ENGINE - LP COMPRESSOR - INTRODUCE A NEW LPC BLEED SCREEN WITH IMPROVED DURABILITY
FEATURES - CATEGORY CODE 6 - MOD.ENG-72-0188

V2500-ENG-72-0188

Replacement of Screen Assembly
Fig.1

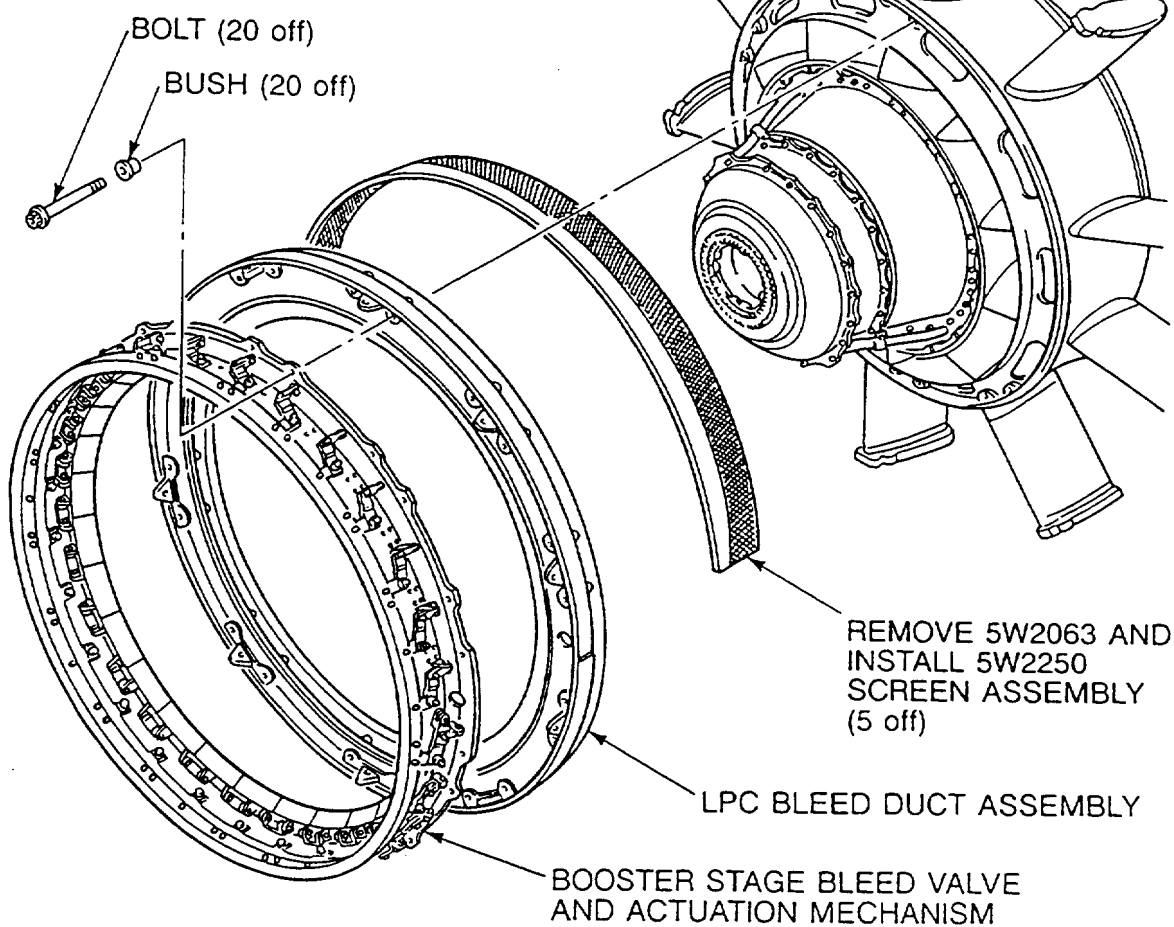
Torn screen net of LPC bleed has been seen on some engines.

New LPC Bleed Screen Assembly provides increased thickness in the line of net and the net is coated with polyurethane.

(a) 5W2250 Screen Assembly supersedes 5W2063 Screen Assembly.

- (1) When you install the Screen Assembly by the approved procedure given in Reference (2), Chapter/Section 72-32-00, Assembly-08 Config-1, install 5W2250 Screen Assembly. Refer to Figure 1.
